Control No. 970801A	To: FERMILAB	JTY / KTY Appr.
Last Revision 03	Part no. DO-CAL-PA-V2-A	Drawn By: 7/18/97 R. Blood

SCHEMATIC

Sheet 7 of 9

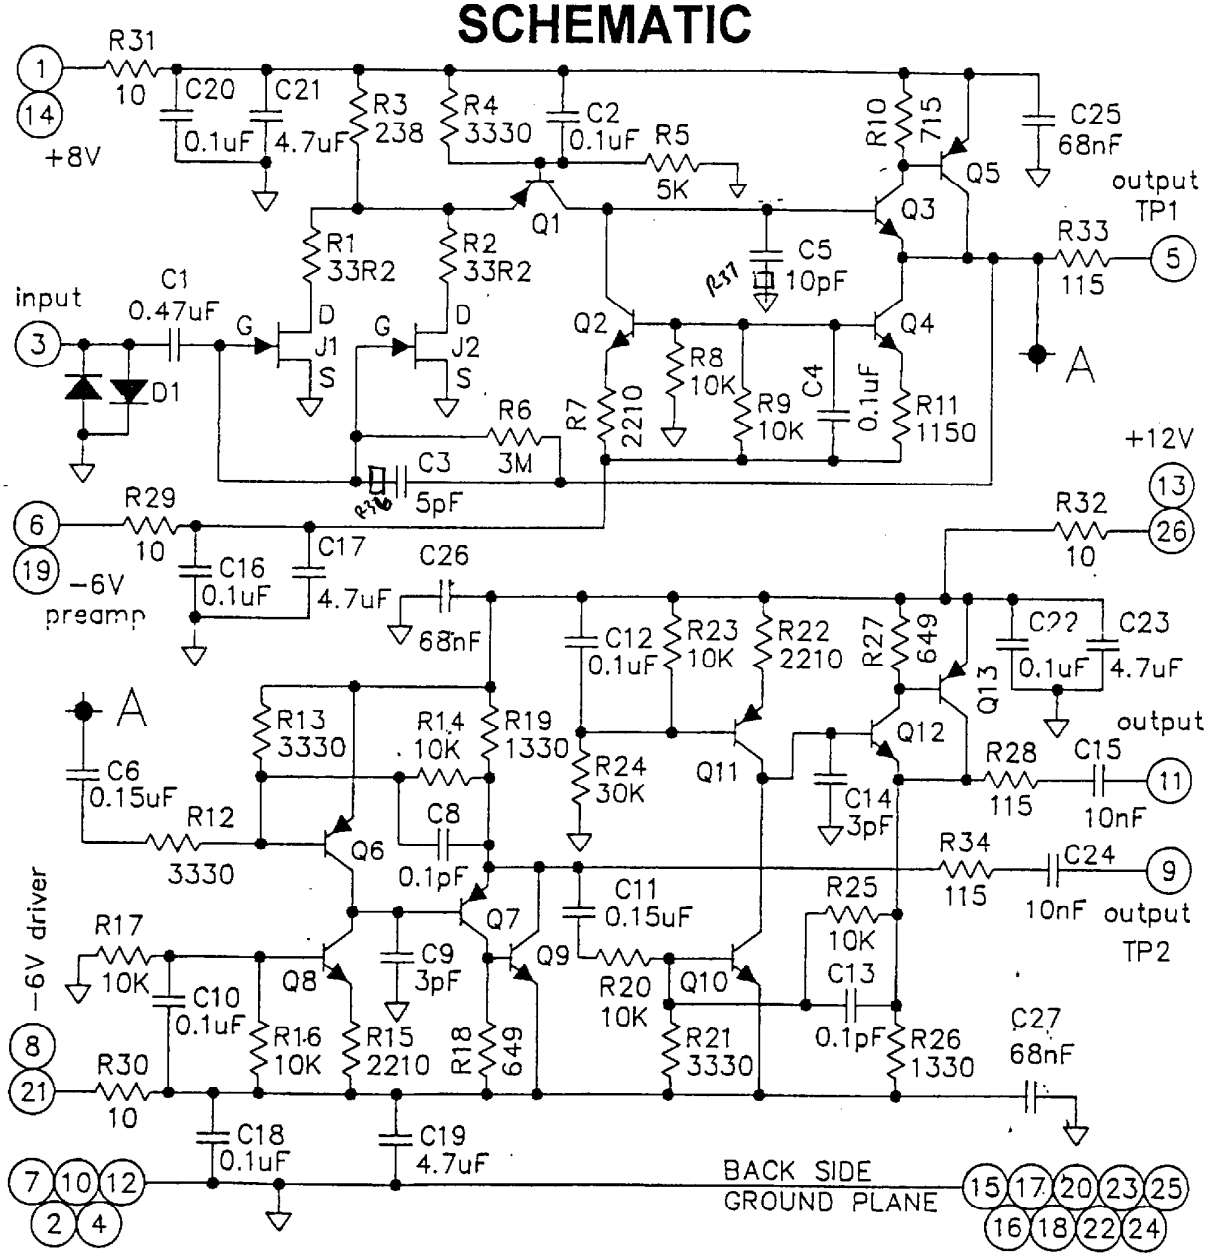
Rev.		By / Date
03	Changed R3 from 178 to 238 ohms.	RB 6/15/98
02	Modified to match Fermilab's changes,	RB 9/5/97
